Re. Case Number 21-0868-EL-BGN: Scioto Farms Solar

Heartland Earthworks Conservancy

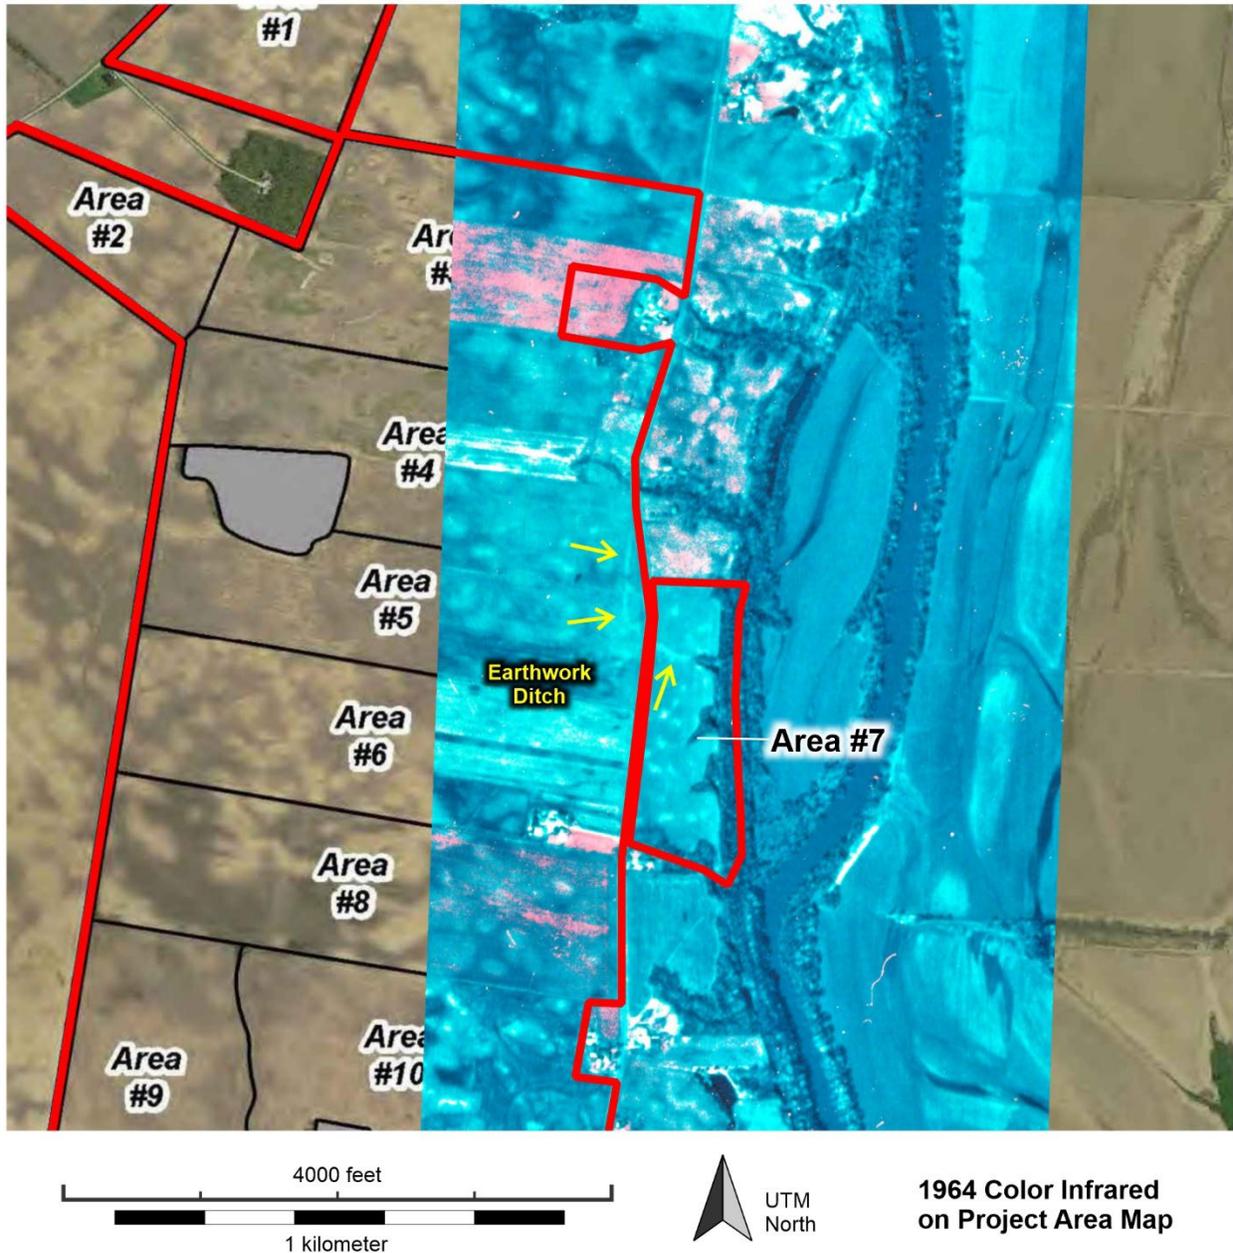
As previously stated, Commonwealth made no effort in the field to identify this likely NRHP eligible landmark despite the fact that SHPO has it recorded on their Online Mapping System in the project area. Because its “surficial evidence” has been erased by plowing, geophysical instruments must be used to identify it. We have indicated its location on the below color infrared aerial photograph.

We reply that based on the preliminary project design map, 33PI10 will be impacted by construction of access roads, fencing, inverter pads, solar arrays, and vegetative screening. We recommend additional archaeological investigation in the form of geophysical survey to identify 33PI10 in order to comply with the Board's rules.
